04458/GB/RS/51717/WL

Re: Manchester Central Arena / Render Horizontal Joint Design

This letter is to bring to your attention the proposed change of horizontal joint design to the external façade render system.

Figure No. 1: Proposed labyrinth joint design

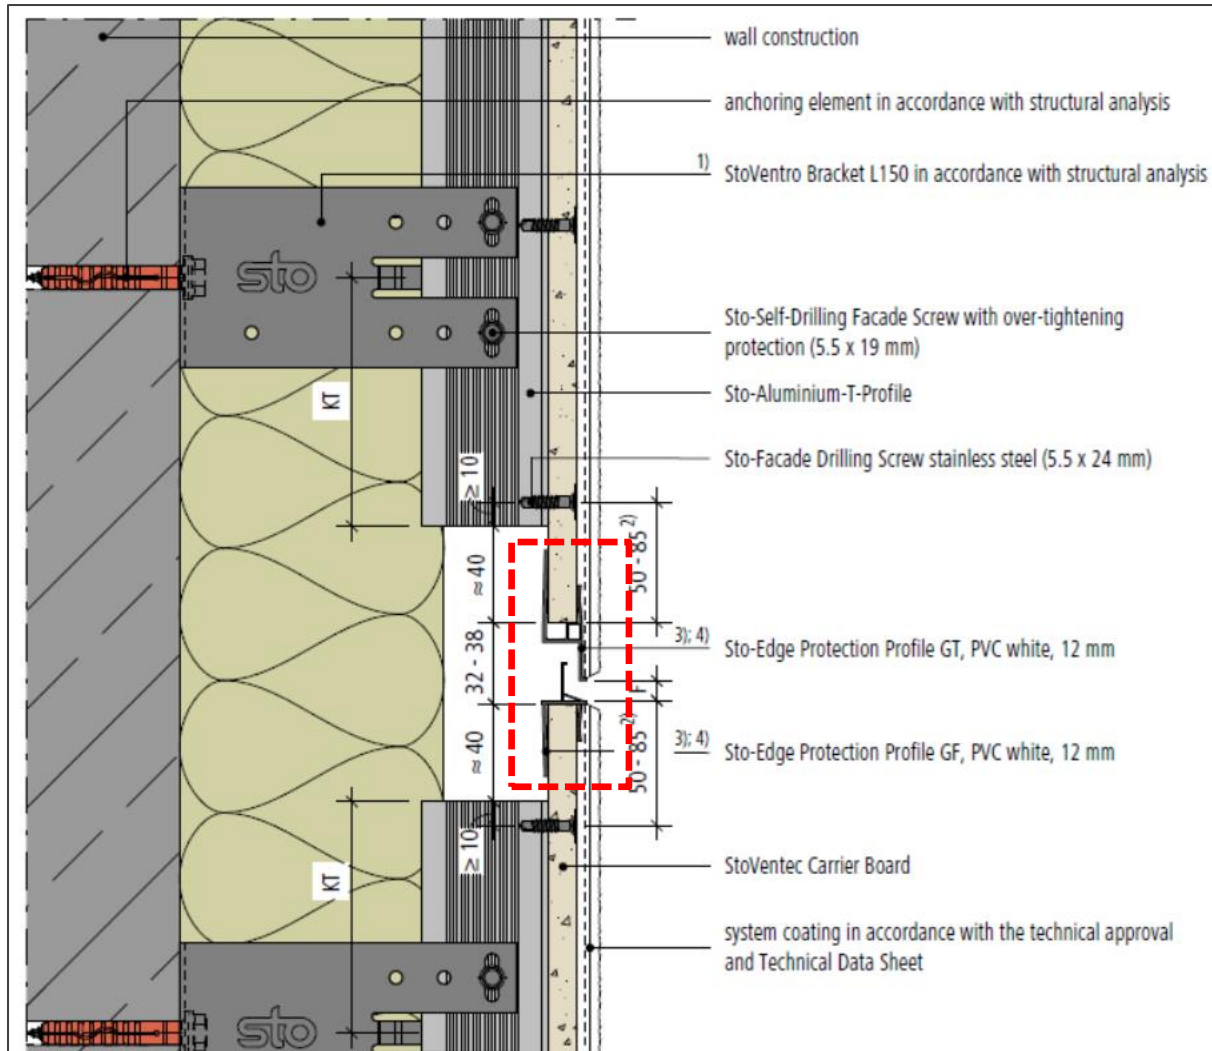
For the remedial works, the timber framework, supporting the render carrier board, will be replaced with vertical sub-frame members, which will be fixed to the structural framing system (SFS) using horizontal 'top hat' sections and helping hand brackets. We recommend considering a labyrinthed joint instead of the open joints currently used. The design of the proposed labyrinth joint utilises continuous PVC edge protection beads on either ends of the carrier board (refer to Figure No. 1 in the Appendix section). This will require reducing the height of the carrier board in order to fix the PVC labyrinth joint beads to the top and bottom edges of the board.

The labyrinthed joint has a number of benefits over and above the open joint design. Currently, the 12-15mm wide open joints are quite prominent even from a distance and a continuous, dark shadow line is observed throughout the building at every floor level. With the labyrinth joint, the appearance will appear much more monolithic and the overall aesthetic appearance will be improved. Additionally, the design of the labyrinth joint PVC bead promotes surface drainage. This will prevent any staining at the joint edges as currently observed due to the open joint flat edge surface (refer to Photograph No. 3 in the Appendix section).
